WNB4 - Replacing Interior Surveillance Sensor (Workshop Campaign)

Model Line: **Taycan (Y1A)**
Taycan Cross Turismo (Y1B)
Taycan Sport Turismo (Y1C)

Concerns: **Interior surveillance sensor**

Interior surveillance sensor installation position

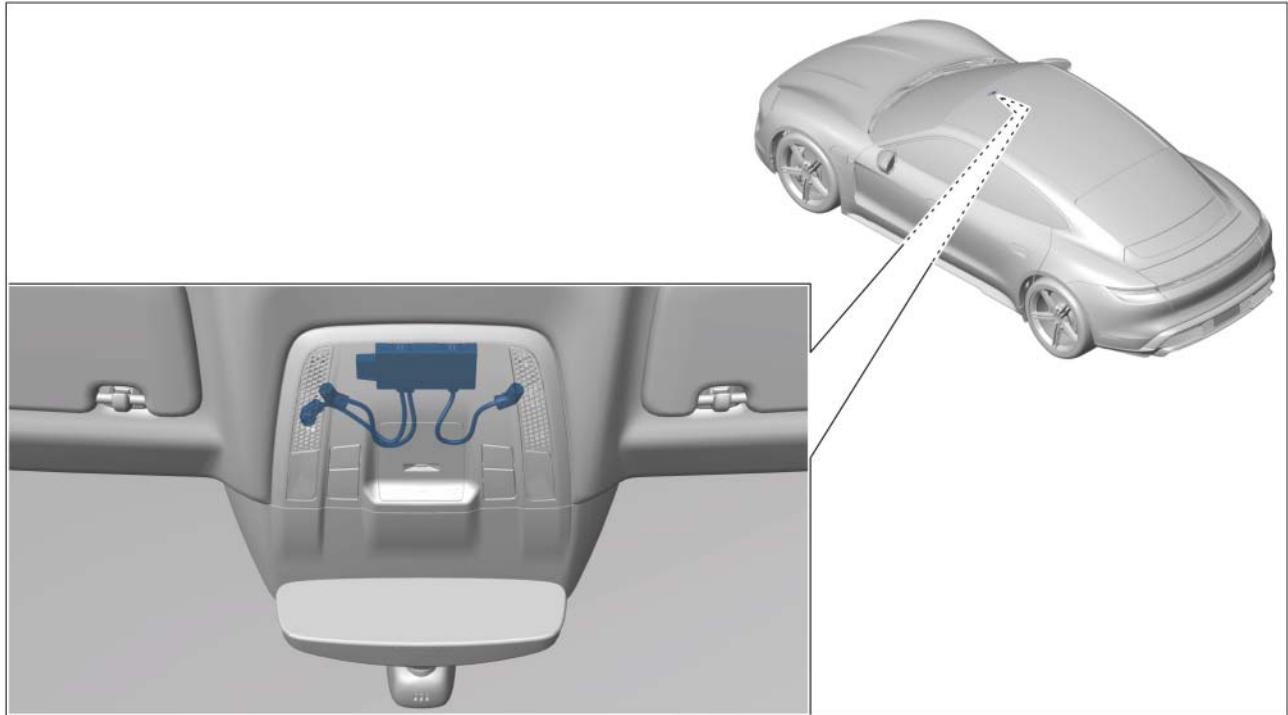
Information: **There is a possibility that the main antenna (LTE reception) of the communication control unit on the affected vehicles can interfere with the function of the adjacent sensor for interior surveillance by means of electromagnetic signals in the area of the mirror base.**
 If this happens, the alarm system can be triggered unwarranted by the interior surveillance system.

Action required: Read out the hardware part number of the interior surveillance sensor and depending on the result of the check, either:

- Re-coding rear-end electronics control unit

- Replacing interior surveillance sensor and re-coding rear-end electronics control unit
